CITY OF ALBUQUERQUE

Re: Comfort Inn & Suites
411 McKnight Ave. NW
Traffic Circulation Layout
Architect's Stamp 6-26-17 (H14D068)

Based upon the information provided in your submittal received 7-11-17, the above referenced plan cannot be approved for Building Permit until the following comments are addressed:

TRAFFIC
CIRCULATION
LAYOUT

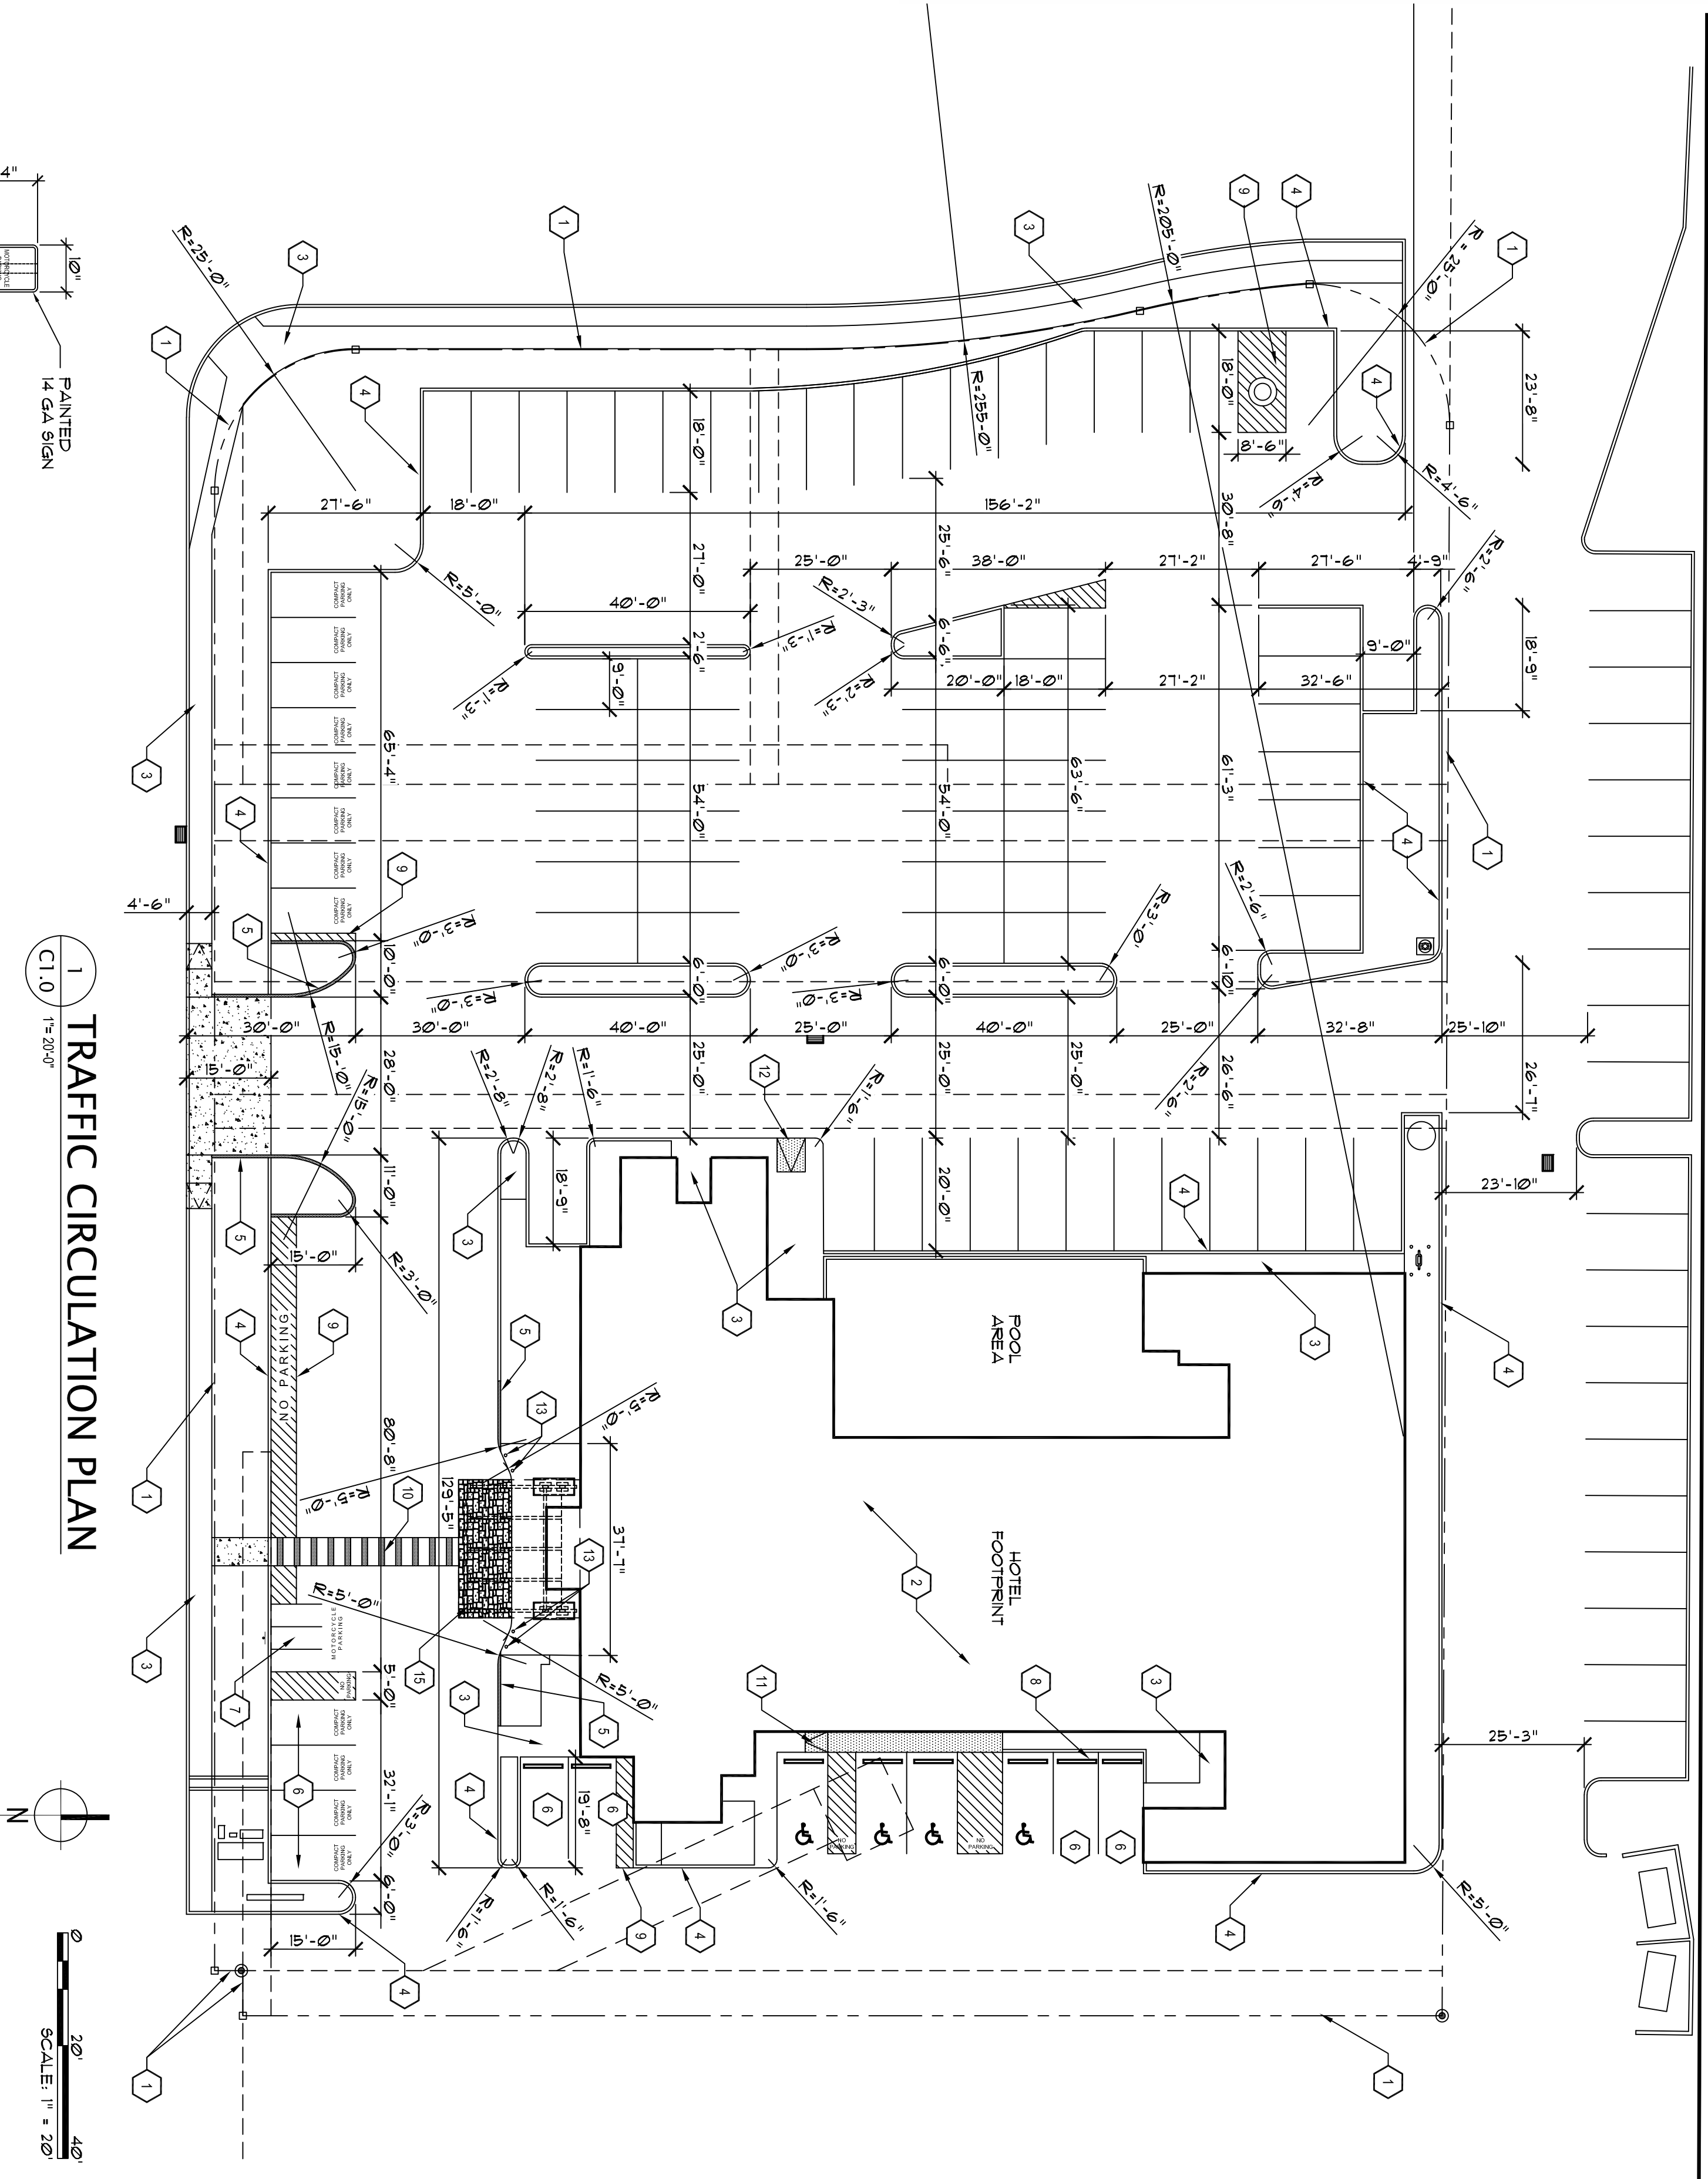
1. Curb cut on the south side of the site is NOT allowed.
2. Label all streets name on site plan.
3. Identify the right of way width, the Ally on the east side of the site and street widths on McKnight Ave.
4. Per the zoning code, a 6 ft. wide pedestrian pathway is required form the public sidewalk to the building entrance. Is this pathway flush on the sidewalk? Please provide details.
5. Identify the drive aisle width between the parking space and the building on the southeast side of the building.
6. Sidewalk must be moved to property line.
7. Provide all compact parking spaces dimensions.
8. Provide Truncated Domes on the ADA ramp on the Right Of Way.
9. Please fix detail #11 "8/C" to "6/C".
